PLANNING COMMISSION
SUMMARY MINUTES
JANUARY 9, 2024
5:00 P.M. Training and Organizational Session
7:00 P.M. Planning Commission Meeting

Bodega
12021 Sheraton Lane
PUD Amendment / Preliminary Development Plan
Application# 20230909
March 12, 2024

BODEGA
12021 SHERATON LANE
PLAN REVIEW PERMIT #20230909
24020103
FEBRUARY 27, 2024

PLANNING COMMISSION
ENGINEERING REVIEW

SITE LAYOUT PLAN
BODEGA AT SUGARCREEK
CROSSINGS OF SPRINGDALE
SPRINGDALE LAKE SUBDIVISION
CITY OF SPRINGDALE, HAMILTON COUNTY, OHIO

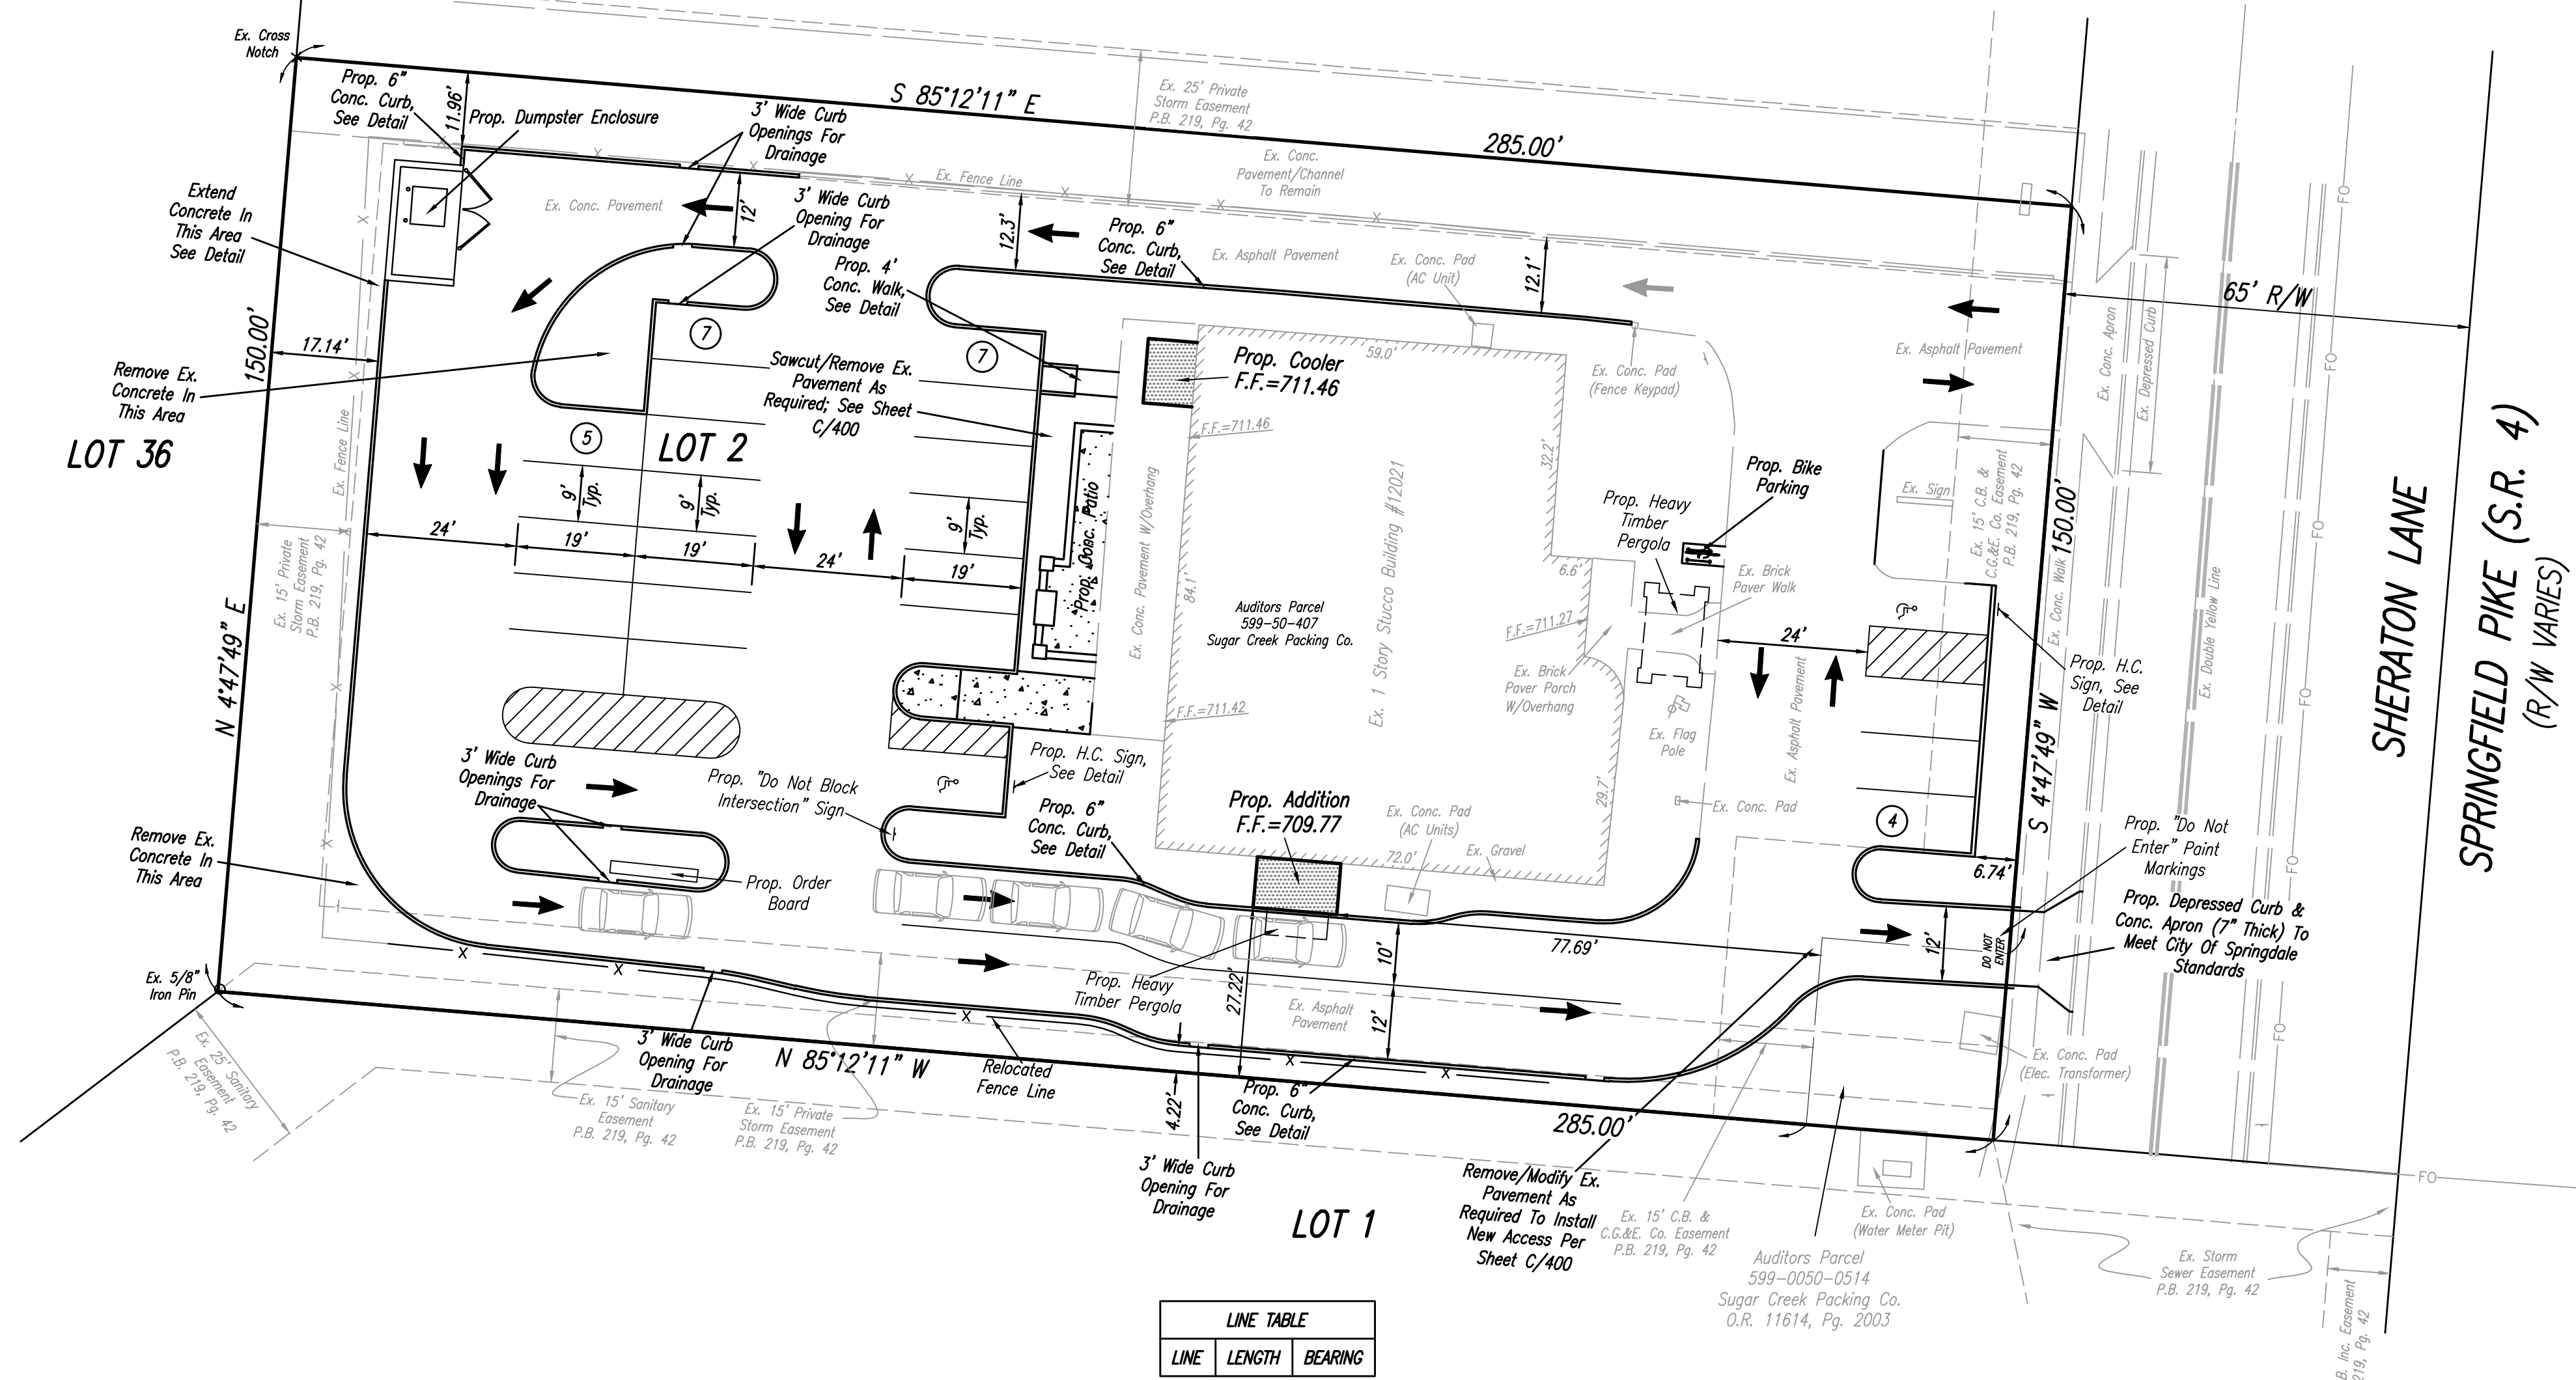
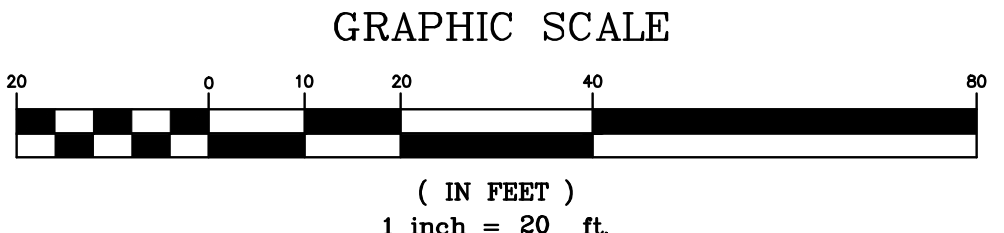
The 1,955 square feet of retail space is required to have seven parking spaces. The applicant has not provided the dimensions of the outdoor patio area which will require parking per Section 153.253 (E) (8) (e). Total required parking, excluding the outdoor dining area, is between 29 and 40 spaces. Planning Commission will need to determine if 23 parking spaces proposed by the applicant is sufficient to serve the uses.

- 10) The south side of the building is proposed to have a drive thru structure. The applicant is proposing a 10 foot wide drive thru lane and a 12 foot wide bypass lane. Five stacking spaces (10' x 20') per Section 153.304 from the pick-up window are required and have been included on the site plan, however, these spaces cannot be provided without the potential to block traffic within the parking lot. The applicant acknowledges that the five required stacking spaces cannot be provided and is requesting that only four stacking spaces be required. The applicant needs to indicate how the bypass and drive thru lanes will be separated. The proposed menu board with audio does not meet the required 100' setback from a residential use per Section 153.253 (E) (4) (e). A 4'- 6' screen, fence, or wall is required for the drive thru structure adjacent to the residential use to the south. Per Section 153.304 (D), Planning Commission may approve a reduction in the requirements for drive thrus if they find that there is an exceptional situation or condition that justifies such action. Staff does not believe the site circulation will function adequately and the drive thru will not be buffered from the adjacent residential use to the south. Staff would recommend that the drive thru be eliminated.

1. Per City regulations 150.13 of the City's regulations, streets shall conform substantially to the thoroughfare plan adopted by the planning commission and any revisions or amendments thereto. The City's current Thoroughfare Plan (1998) classifies Sheraton Lane as a local street with a right-of-way width of typically 50' and that the spacing of access points should be one hundred feet (100') measured from point of curb return to point of curb return. Also, the number of access points should be limited to one per tract except where it can be demonstrated by the developer that an additional curb cut will benefit traffic movement.

- a. A public sidewalk exists on the west side of Sheraton Lane. The submitted revised site plan dated January 26, 2024, does not include any proposed pedestrian connections to the public right-of-way. The applicant's response letter dated January 26, 2024, indicated that a bike rack/parking area has been added to the front entrance of the building however the owner does not plan to install a sidewalk connection at this time.

3. The project site is currently accessed by a single entrance. The submitted revised site plan dated February 22, 2024, includes the construction of an additional exit drive. The below comments apply if the additional exit drive is warranted.

The submitted revised site plans dated February 22, 2024, indicated that the existing site impervious area is 32,973 SF while the proposed site impervious area is 31,744 SF, providing an approximate 2.8% reduction in site impervious area. This is acceptable to Staff.

- 1) The two members of City that serve on Planning Commission determine that, pursuant to Section 153.255 (H), the request is a major amendment.
- 2) Planning Commission determine if the 23 parking spaces provided are sufficient where 29 - 40 spaces would be required by Code, in addition to parking required for the unknown outdoor patio area.

- 10) There is to be no modification of light fixtures or poles on the site without staff review and approval per Section 153.153.351.
- 11) The existing ground mounted signage be brought into conformance with the requirements of Sections 153.459 (C) (3) and 153.257 (C) (4) and (E) (2).
- 12) Planning Commission determine if it is appropriate to include illuminated “chalk signs” on multiple building elevations, which are not permitted by Code.
- 13) Planning Commission determine that the proposed drive thru use is appropriate in view of the fact that it does not meet a number of the requirements for Drive Through Structures contained in Section 153.253 (E) (4), including required stacking, location of the order station, screening from a residential use, and separation of the drive thru / bypass lane designation.
